Quality Control Check Report. Stage: After Finishing Stage III (Apartments)

Flat No	518	Other	←	Sl. No.	42584
Company	MRGV	Project	BRGV	Phase	←
Prepared by	Saikin	Sign	<i>[Signature]</i>	Date	14-11-2023
Project Manager	Sarwan	Sign	<i>[Signature]</i>	Date	14-11-2023
Previous stage report no.		42107	Report filed and signed by PM		☒ Yes ☐ No
Checked By MD on		MD Sign		For filling	☐ Yes ☐ No

Details of Additions & Alterations

ELECTRICAL PLAN

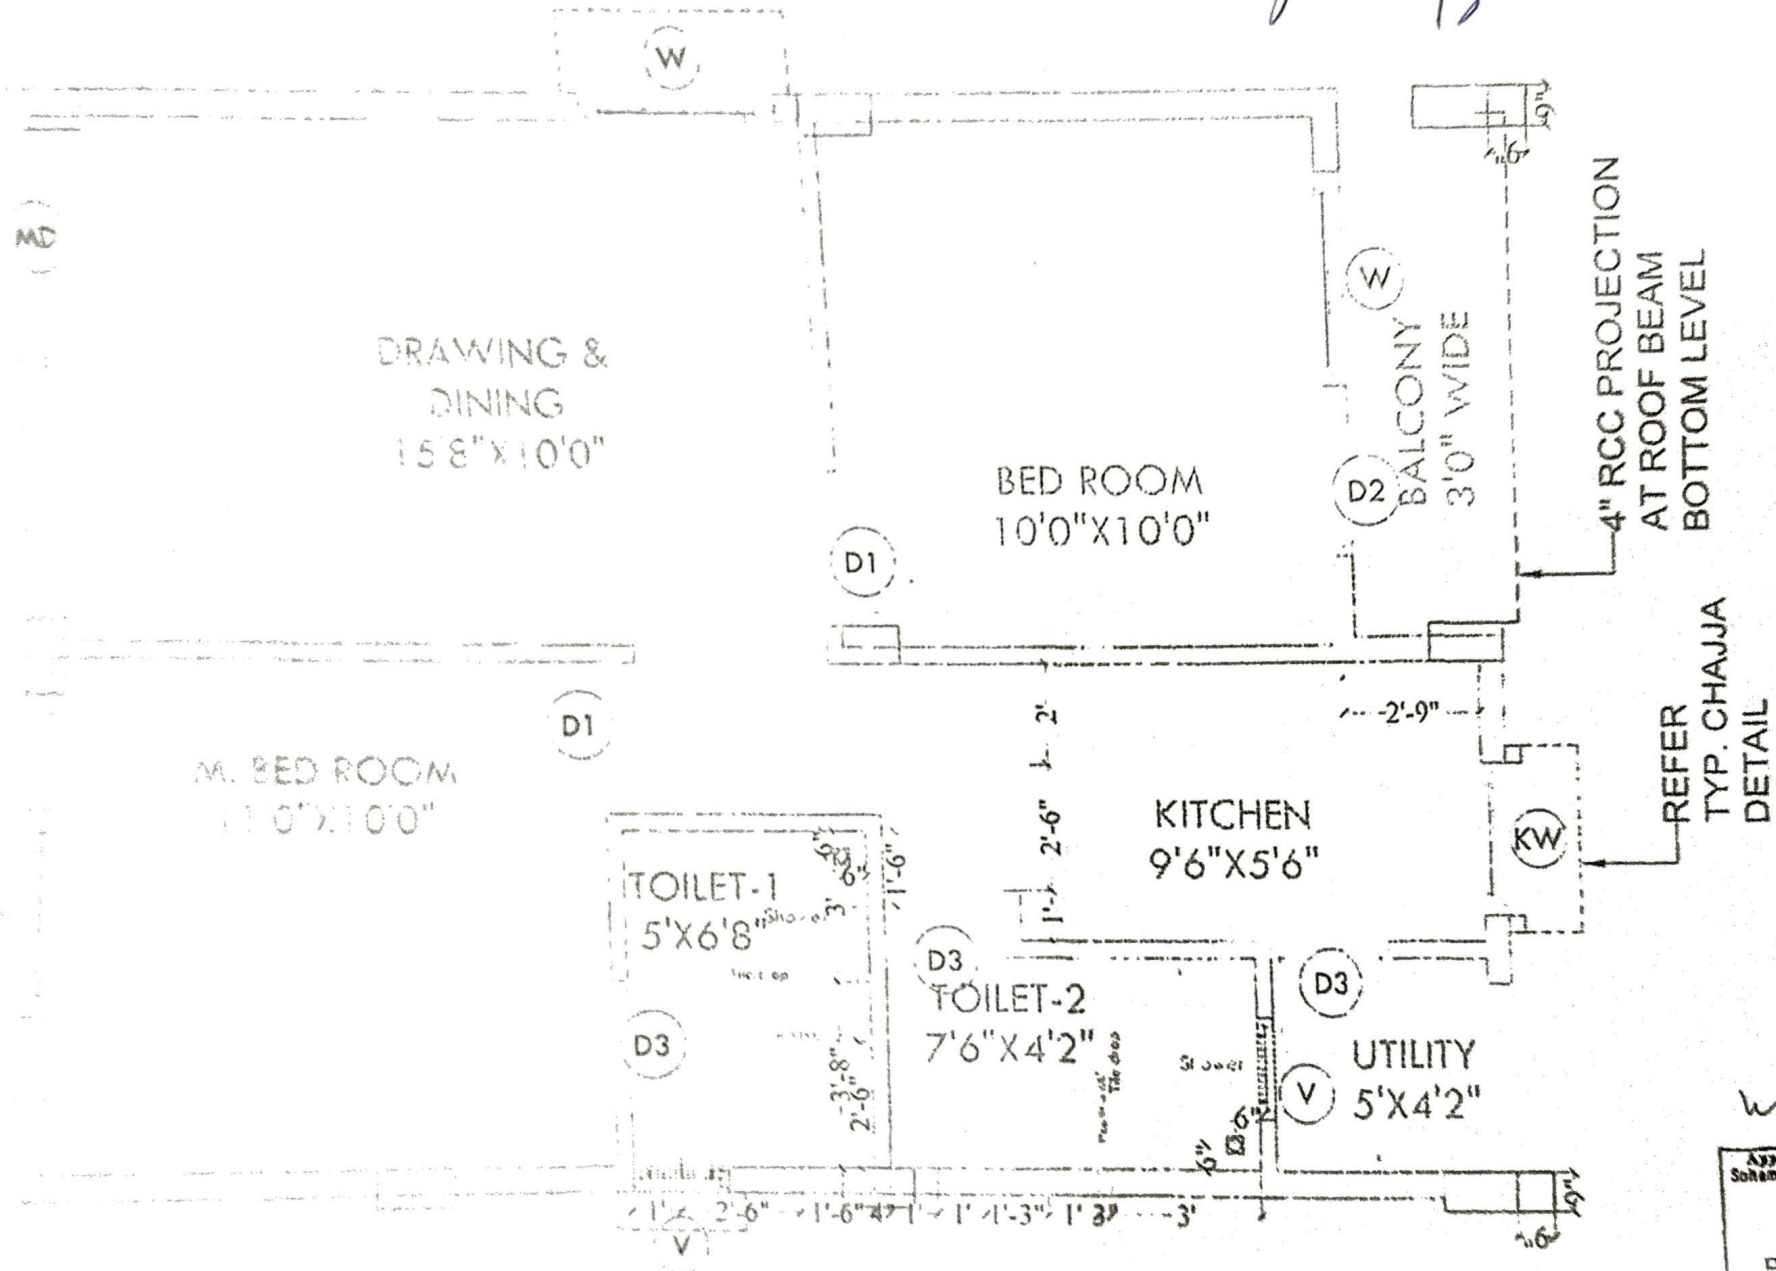
Changes in electrical points: (mark on plan)

- ① 16 amp Extn for kitchen
- ② 16 amp Extn utility.
- ③ Extn pit for T.V. subs.
